# UNITED STATES PATENT AND TRADEMARK OFFICE

**Office Action Summary**

10/782,961

MARUSHIMA ET AL. EP

**Fig. 4B****Fig. 4C**

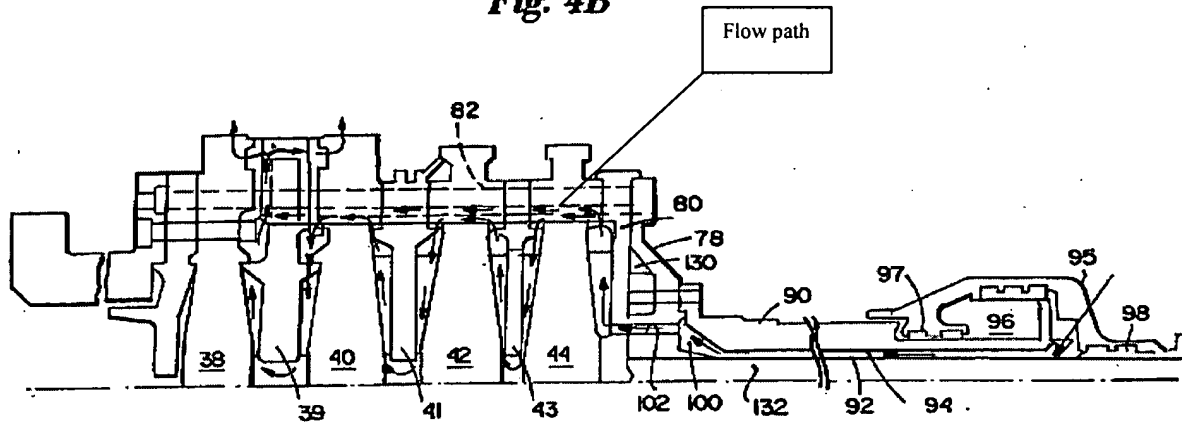
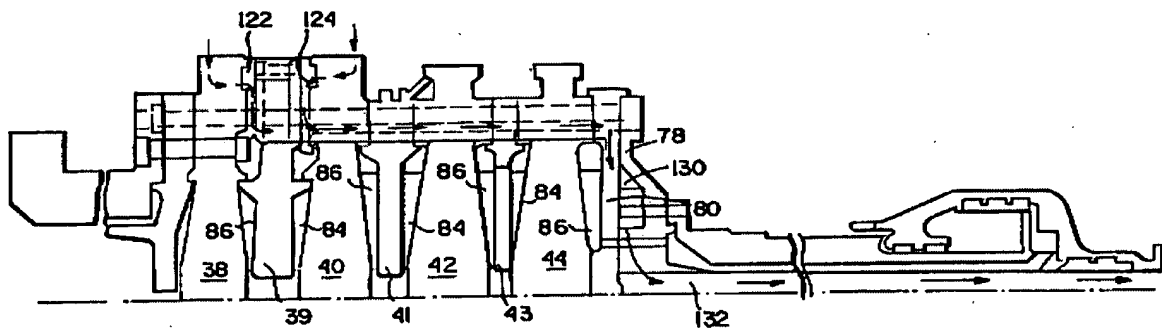
With respect to claim 11, Carreno teaches a gas turbine which a rotor shaft comprises a plurality of discs 38, 40, 42, 44 each having a plurality of moving blades arranged annularly on the peripheral portion, and spacers 39, 41, 43 arranged between said discs, said respective discs 38, 40, 42, 44 and spacers being arranged in an axial direction in turn, comprising: gap portions 84, 86 formed between rotor axis side regions of said discs 38, 40, 42, 44 facing said spacers 39, 41, 43 and adjacent spacers; a supply flow path 92 for supplying refrigerant for cooling to said moving blades and a recovery flow path 132 for recovering heated refrigerant, each of said

supply and recovery flow paths being provided in said rotor shaft; a flow path (see Figure 4B) for introducing fluid into said gap portions 84, 86, provided in said discs; wherein said recovery flow path 132 is arranged on a more radially inner side than said supply flow path 92. See particularly **Figures 4B, 4C** of Carreno above.

With respect to claim 12, **Carreno** teaches a gas turbine which a rotor shaft comprises a plurality of discs 38, 40, 42, 44 each having a plurality of moving blades arranged annularly on the peripheral portion, and spacers 39, 41, 43 arranged between said discs, said respective discs 38, 40, 42, 44 and spacers being arranged in an axial direction in turn, comprising: gap portions 84, 86 formed between rotor axis side regions of said discs 38, 40, 42, 44 facing said spacers 39, 41, 43 and adjacent spacers; a supply flow path 92 for supplying steam for cooling to said moving blades and a recovery flow path 132 for recovering heated steam, each of said supply and recovery flow paths being provided in said rotor shaft; a flow path (see Figure 4B) for introducing fluid into said gap portions 84, 86, provided in said discs; wherein said recovery flow path 132 is arranged on a more radially inner side than said supply flow path 92. See particularly **Figures 4B, 4C**, and column 1 lines 65-67 of Carreno.

**FIG. 25**  
PRIOR ART

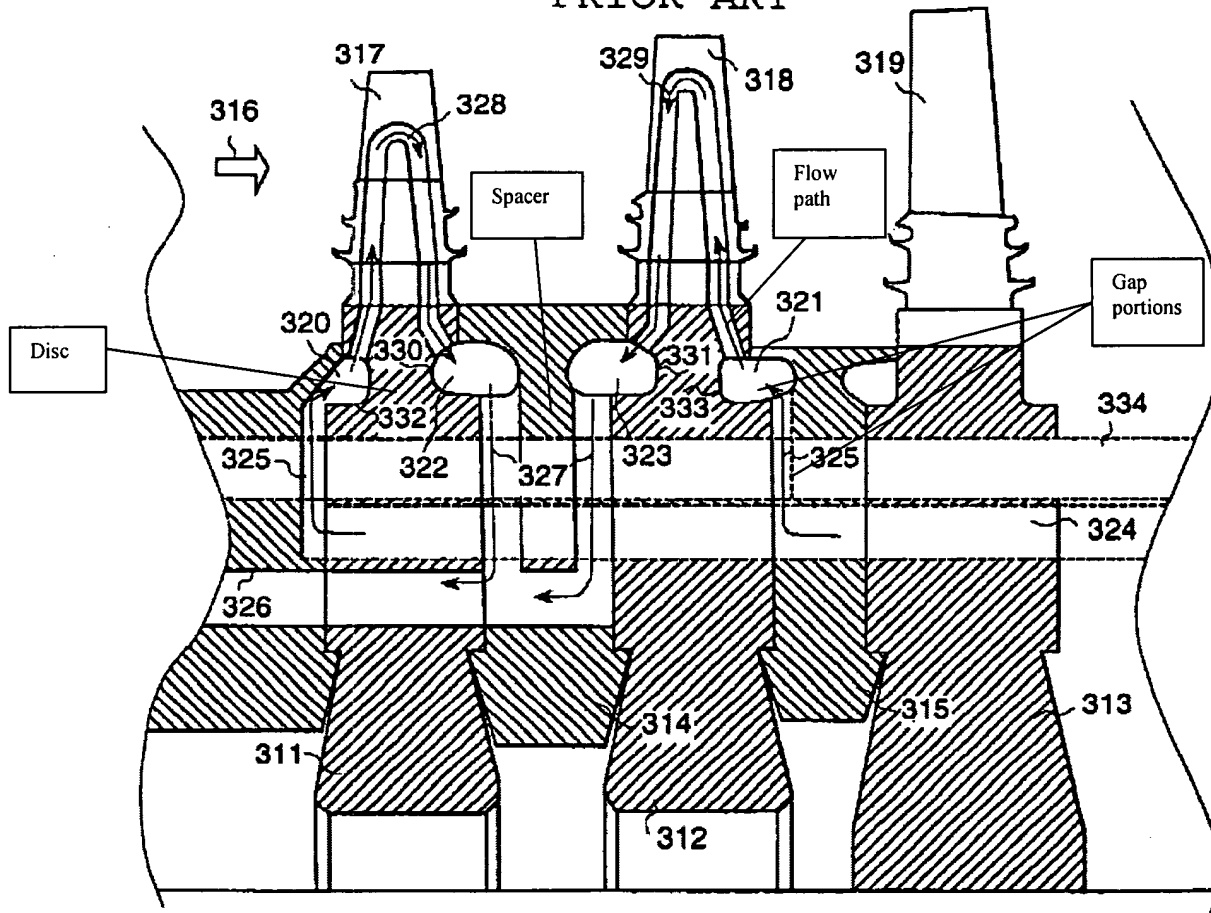
With respect to claim 11, **Akiyama** teaches a gas turbine which a rotor shaft comprises a plurality of discs each having a plurality of moving blades arranged annularly on the peripheral portion, and spacers arranged between said discs, said respective discs and spacers being arranged in an axial direction in turn, comprising: gap portions formed between rotor axis side regions of said discs facing said spacers and adjacent spacers; a supply flow path 324 for supplying refrigerant for cooling to said moving blades and a recovery flow path 326 for

recovering heated refrigerant, each of said supply and recovery flow paths being provided in said rotor shaft; a flow path for introducing fluid into said gap portions provided in said discs; wherein said recovery flow path 326 is arranged on a more radially inner side than said supply flow path 324. See particularly **Figure 25** of **Akiyama** above.

With respect to claim 12, **Akiyama** teaches a gas turbine which a rotor shaft comprises a plurality of discs each having a plurality of moving blades arranged annularly on the peripheral portion, and spacers arranged between said discs, said respective discs and spacers being arranged in an axial direction in turn, comprising: gap portions formed between rotor axis side regions of said discs facing said spacers and adjacent spacers; a supply flow path 324 for supplying steam for cooling to said moving blades and a recovery flow path 326 for recovering heated steam, each of said supply and recovery flow paths being provided in said rotor shaft; a flow path for introducing fluid into said gap portions provided in said discs; wherein said recovery flow path 326 is arranged on a more radially inner side than said supply flow path 324. See particularly **Figure 25**; and column 5 lines 40-46 of **Akiyama**.

With respect to claim 13, **Akiyama** teaches a gas turbine which a rotor shaft comprises a plurality of discs each having a plurality of moving blades arranged annularly on the peripheral portion, and spacers arranged between said discs, said respective discs and spacers being arranged in an axial direction in turn, comprising: gap portions formed between rotor axis side regions of said discs facing said spacers and adjacent spacers; a supply flow path 324 for supplying steam for cooling to said moving blades and a recovery flow path 326 for recovering heated steam, each of said supply and recovery flow paths being provided in said rotor shaft; a flow path for introducing fluid into said gap portions provided in said discs; wherein said flow

path for introducing fluid into said gap portion is constructed so as to be supplied with air extracted from a compressor (column 5 lines 40-46), and said recovery flow path 326 is arranged on a more radially inner side than said supply flow path 324. See particularly **Figure 25**; and column 5 lines 40-46 of **Akiyama**.

Note that **Akiyama** (column 5 lines 40-46) teaches using a combination of air and steam for cooling, just as claimed by the invention in claim 13.
